# SITE DEVELOPMENT PLAN DORSEY CENTER APARTMENTS, PARCEL 'T' 1ST ELECTION DISTRICT HOWARD COUNTY, MARYLAND

PLEASE NOTE THAT THIS REVISION SUPERSEDES AND REPLACES THE NOVEMBER 2020 BEI PLAN SHEET.

| SCALE: AS SHOWN  | DRAWING 13 OF 49   |

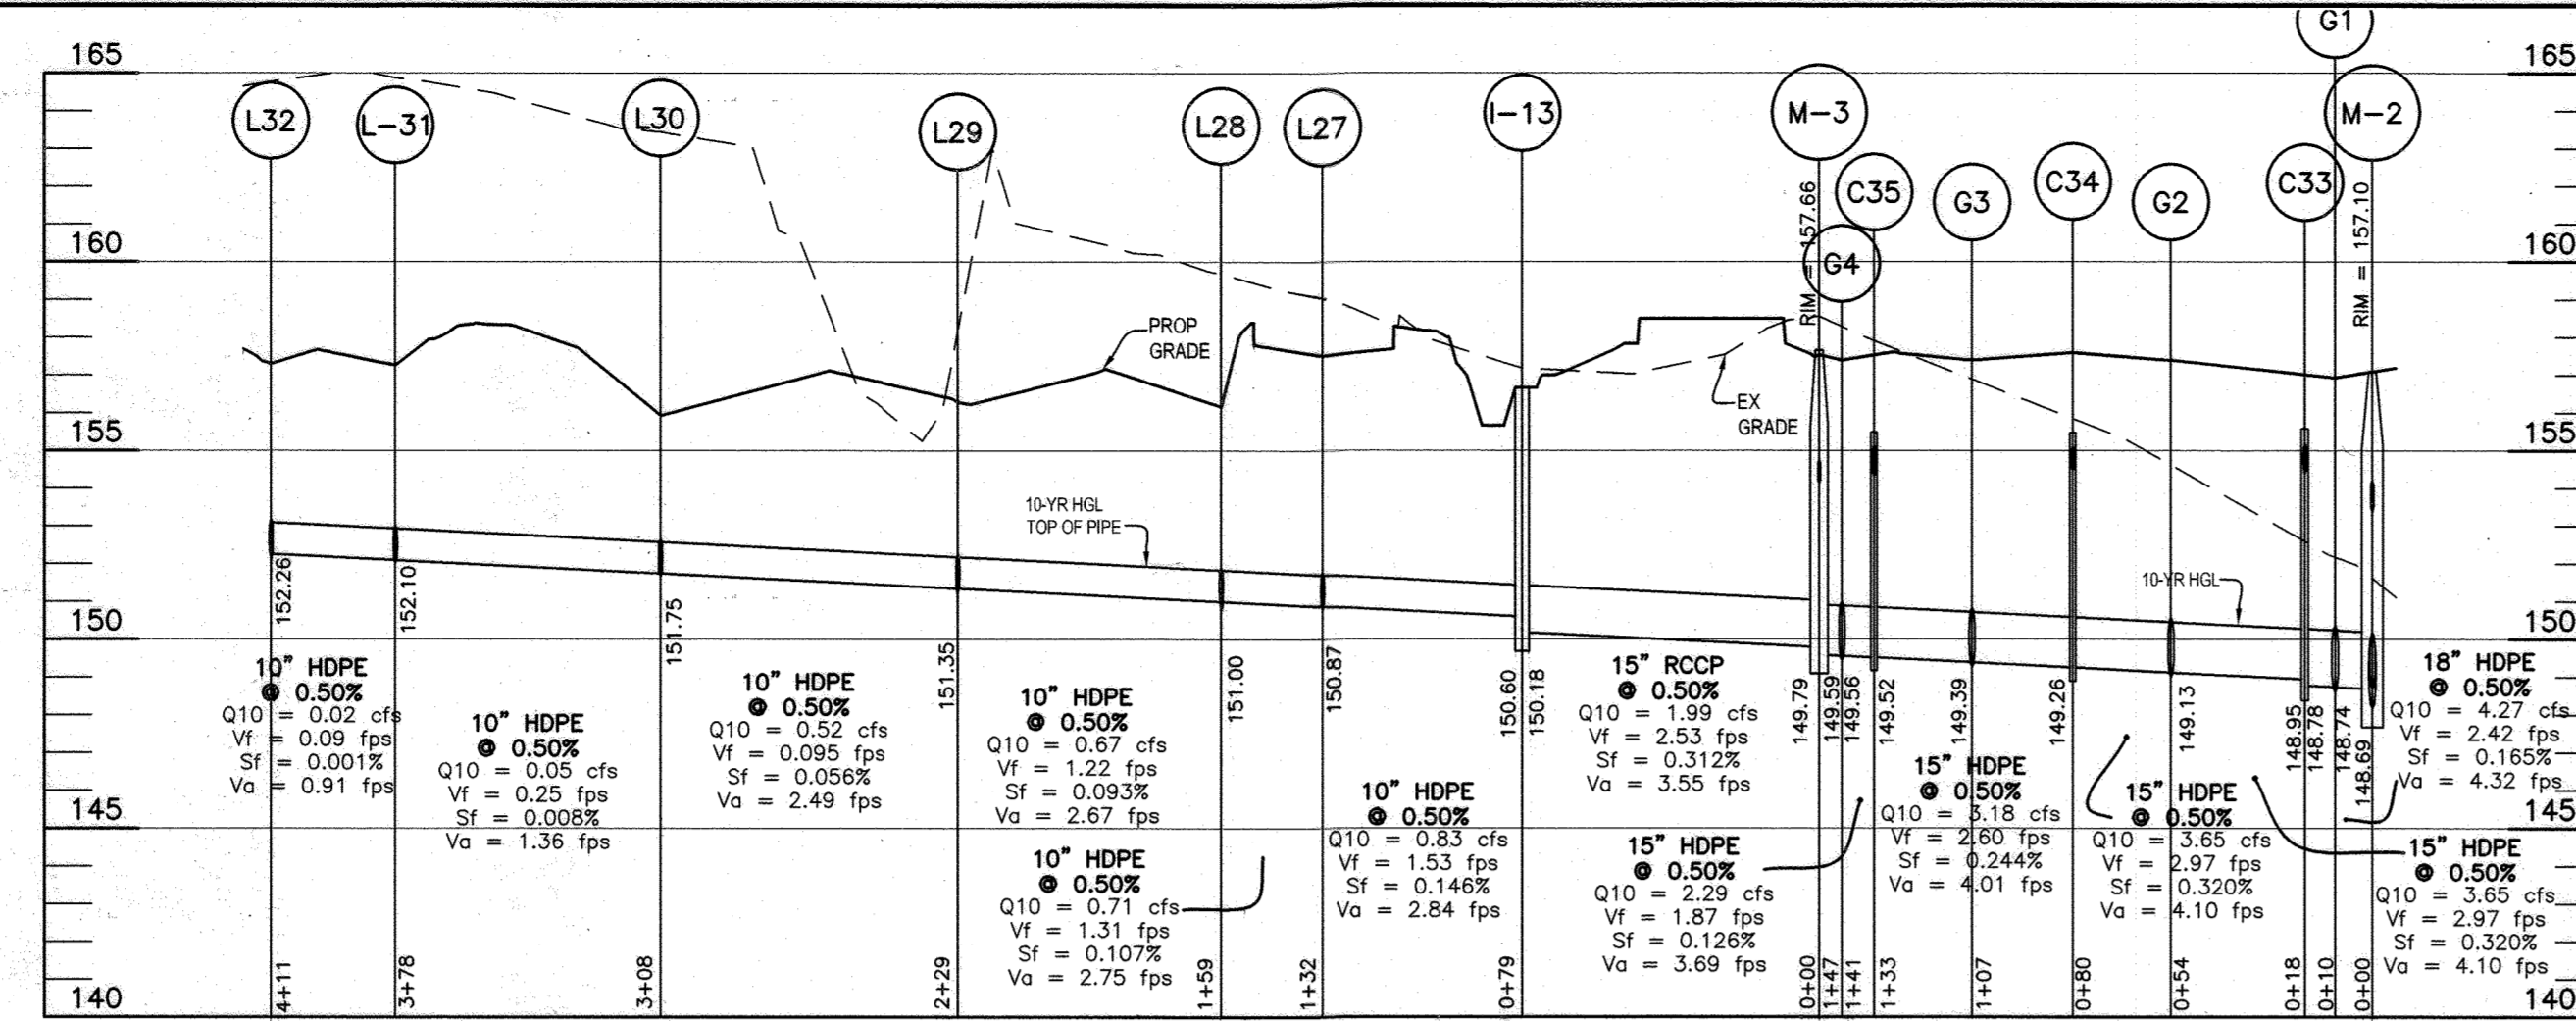
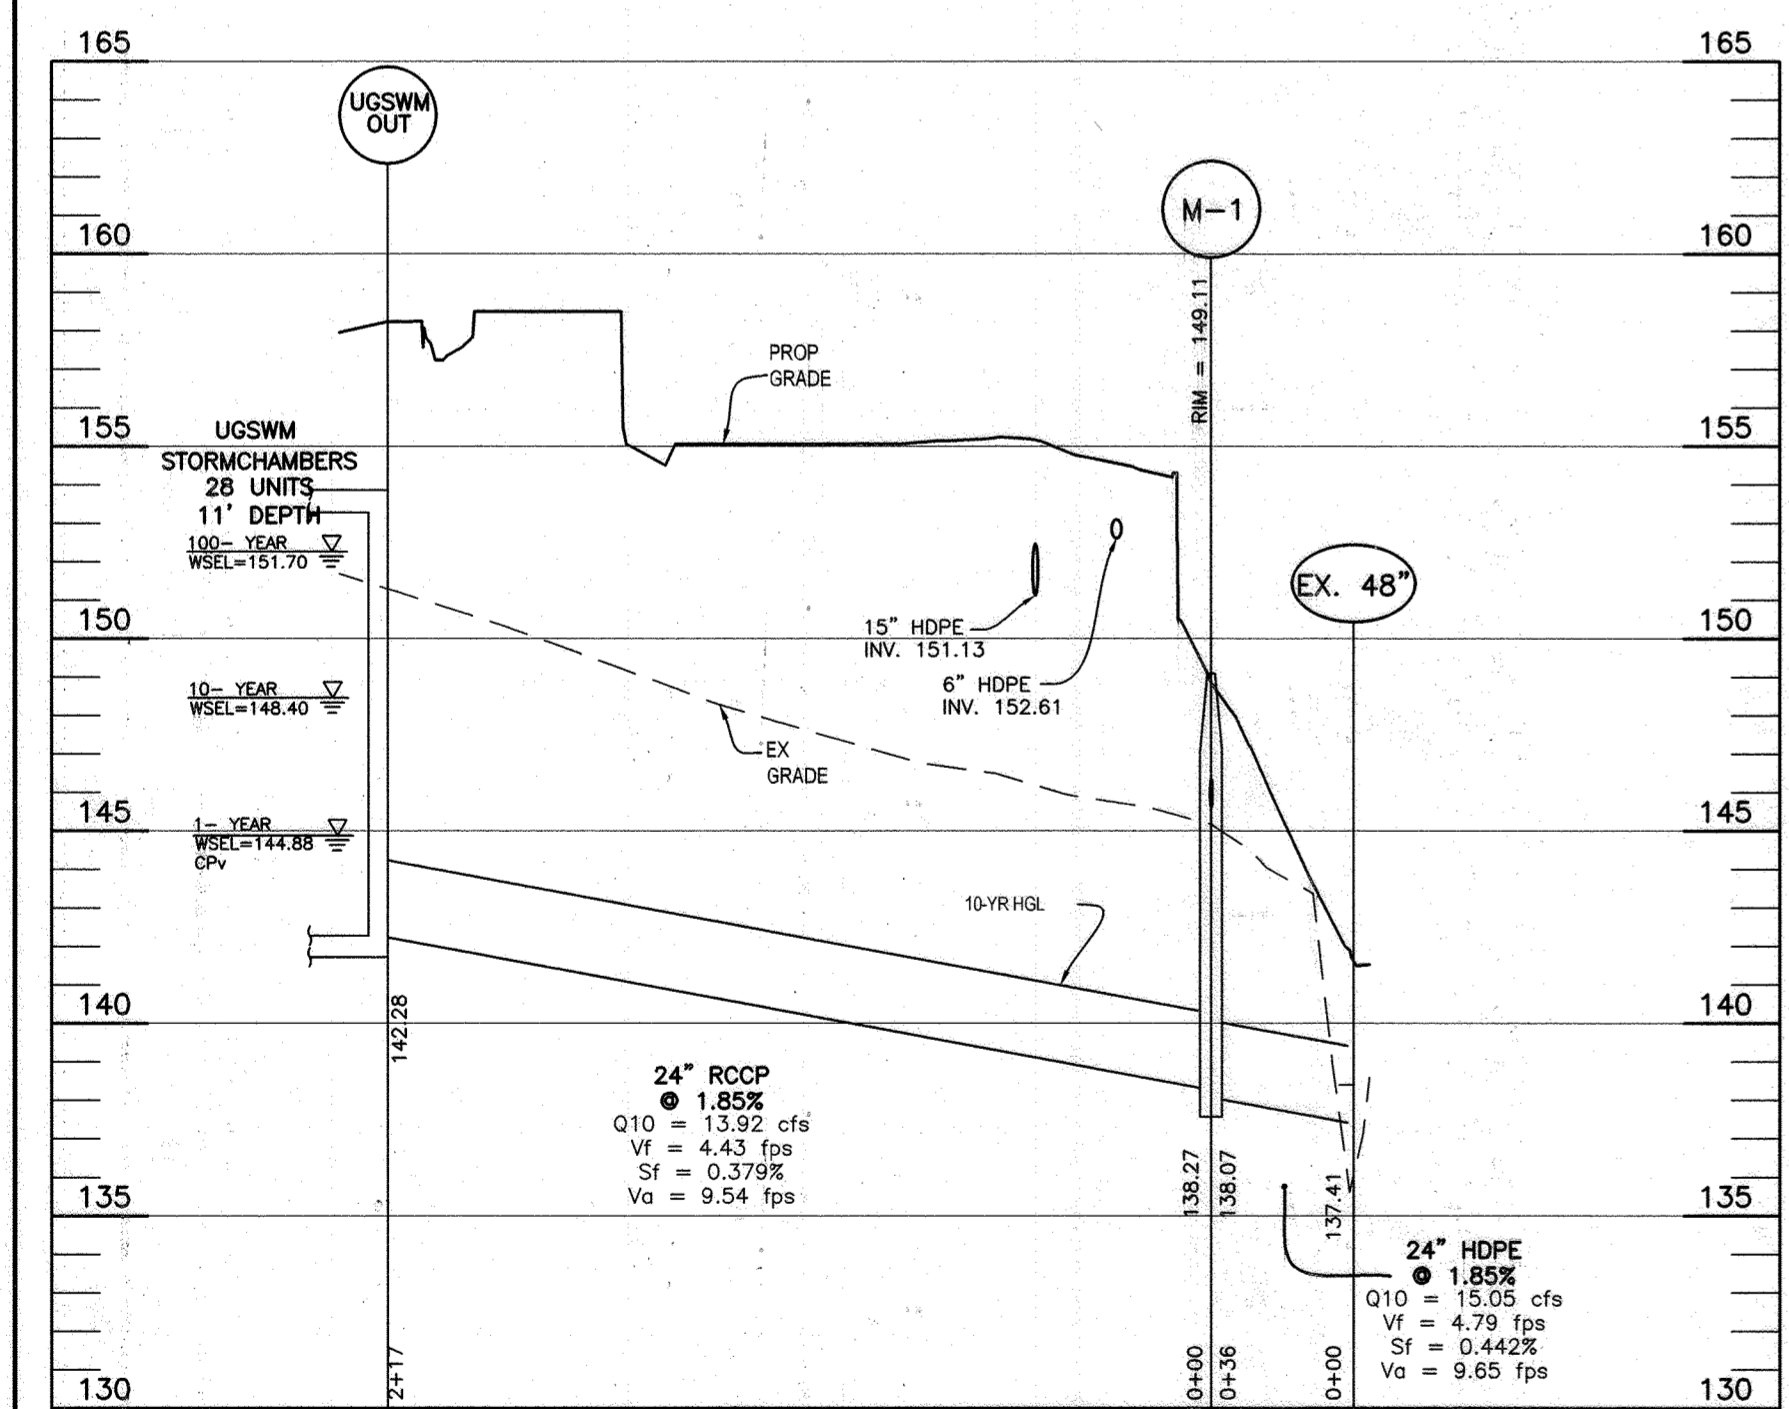
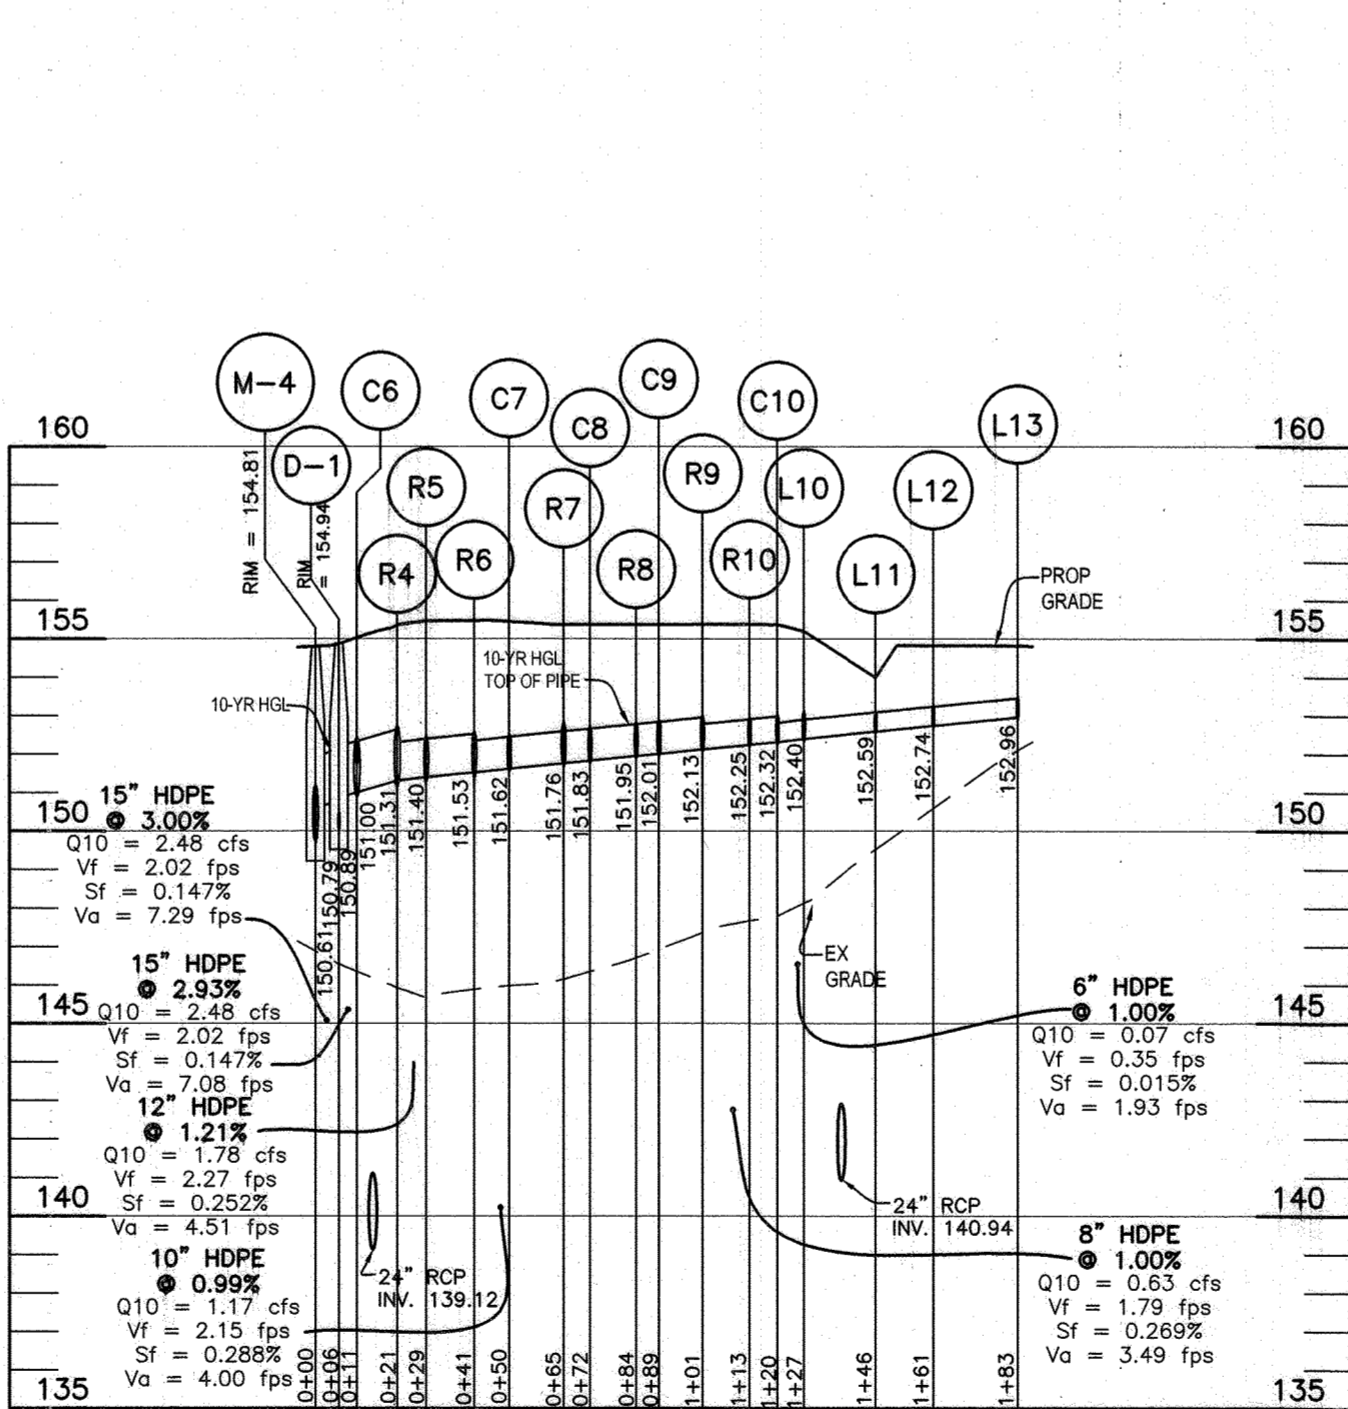
| NO. | DATE | REVISION                                    |
|-----|------|---|
| 1   | 4/23 | REVISED STORM DRAIN PROFILE FROM L30 TO L32 |
